PUBLIC NOTICE **EXETER CONSERVATION COMMISSION** **MONTHLY MEETING**

1. Major Impact Standard Dredge and Fill Wetland Permit Application for 28,418 sq. ft. of permanent wetland impact and 875 sq. ft. of temporary wetland impact for Dade Auto Holdings at 146 Portsmouth Ave. for a commercial auto dealership located at Tax Map 51-1.3-3, 3-4 (Cindy Balcius, SRE Inc.)
2. Committee Reports
 - a. Property Management
 - b. Outreach Events
 - c. Other Committee Reports (River Study, Sustainability, Energy, Tree, CC Roundtable)
3. Approval of Minutes: 10/14/25 Meeting
4. Correspondence

Re: Request for More Information – Standard Dredge and Fill Wetlands Permit Application (RSA 482-A)
NHDES File Number: 2024-02144
Subject Property: 146 Portsmouth Avenue, Exeter, Tax Map #51, Lot #1,3-4,3-3

**Re: NHDES File #2024-02144
Request For More Information
Dade Auto Holdings Realty Trust
146 Portsmouth Avenue, Exeter
Tax Map #51, Lot #1, 3-4, 3-3**

SURCHARGE PLAN

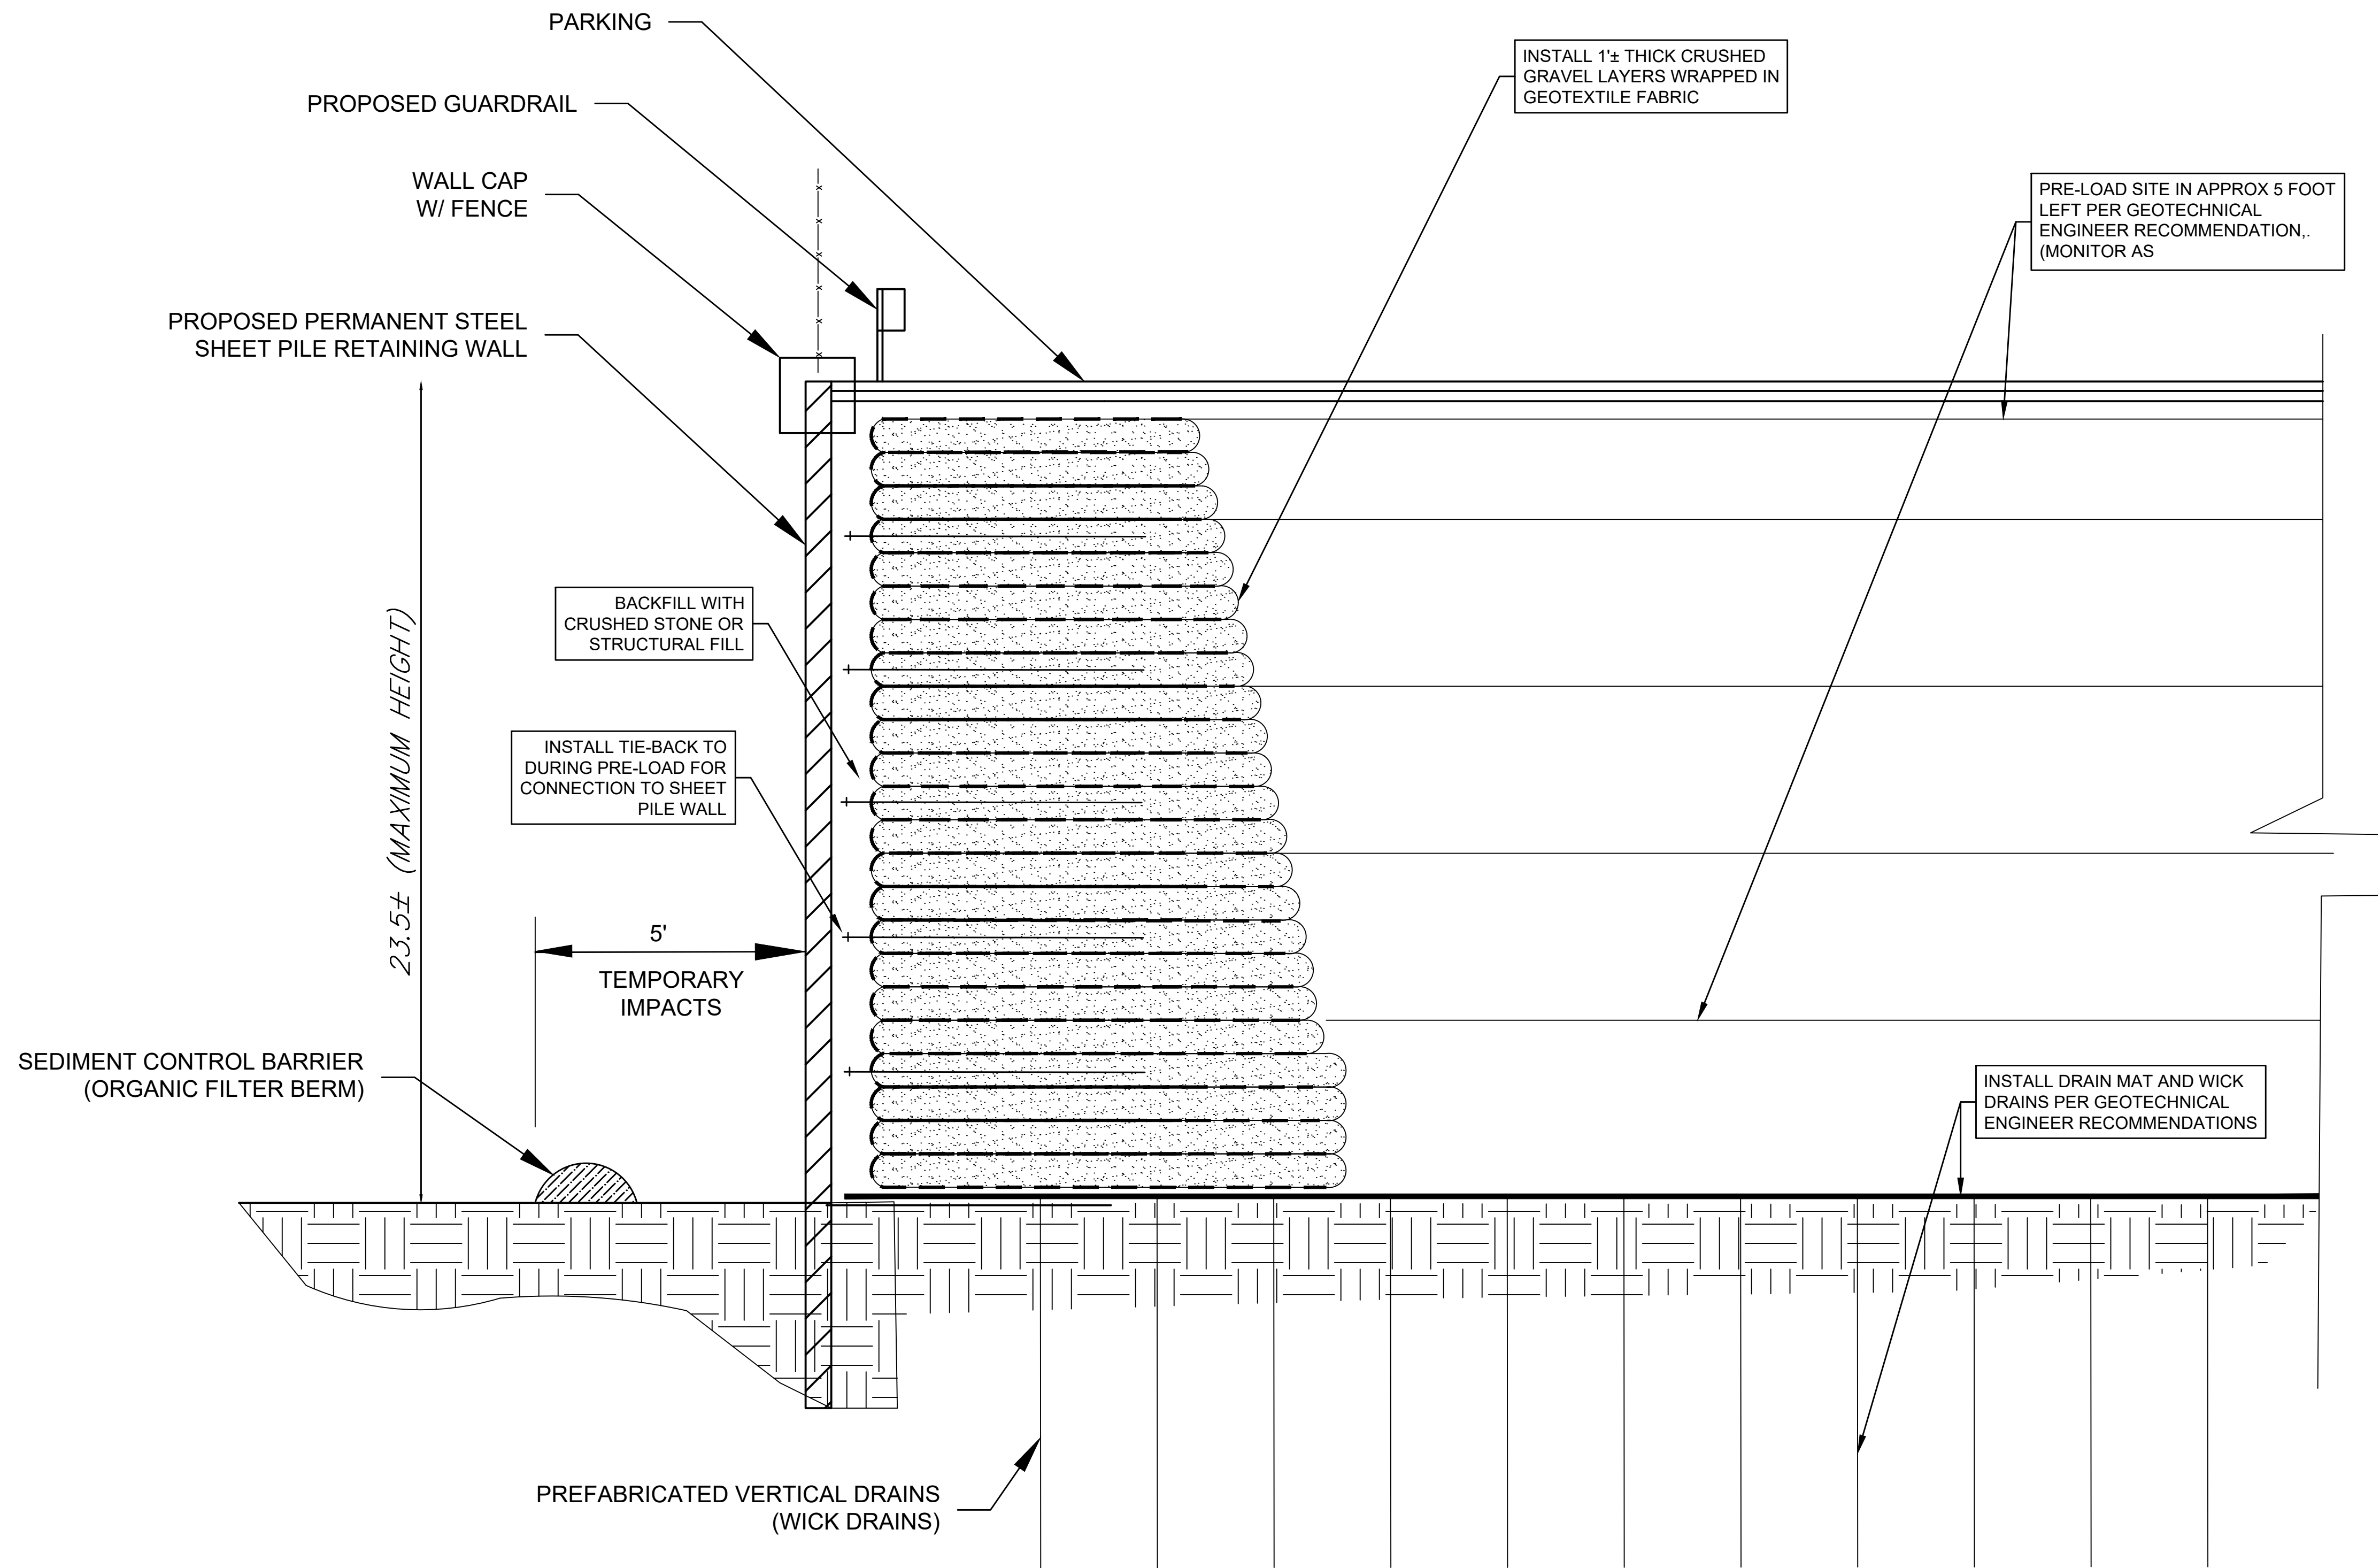
4. Please revise the "Temporary Impact Notes" on plan sheet W-2, titled "Temporary Wetland Impact Plan," to confirm that the temporary fill associated with the installation of the steel sheet pile retaining wall will be in place no longer than one growing season in accordance with Env-Wt 307.11(h).

3 *Surcharging Stormwater*

4. The proposed impact plan and site plan reflect changes made to the surcharging plan. There is no longer a need for the large temporary fill pile outside of the permanent steel sheet piling wall. The temporary fill associated with the installation of the steel sheet pile retaining wall has been reduced to 875 sq.ft. for temporary access for construction and sediment and erosion control installation. The fill required for the surcharging will be placed on the inside of the wall in the permanent impact area eliminating the need for additional impacts. (See Surcharge Plan) Further, a Temporary Sediment & Erosion Control Plan for the Surcharging Phase has been developed and attached as requested by the Exeter Conservation Commission.

The project engineers have worked with Miller Engineering and have developed a Surcharging plan that eliminates the need for long-term temporary fill for the surcharging on the outside of the retaining wall. The temporary impact has been substantially reduced to 875 sq ft for temporary access for construction and installation of sediment and erosion control BMP's. The building footprint surcharging will take place within the building footprint and proposed permanent impacts. Also included in the revised plan set is a temporary sediment and erosion control plan for the surcharging phase of this project.
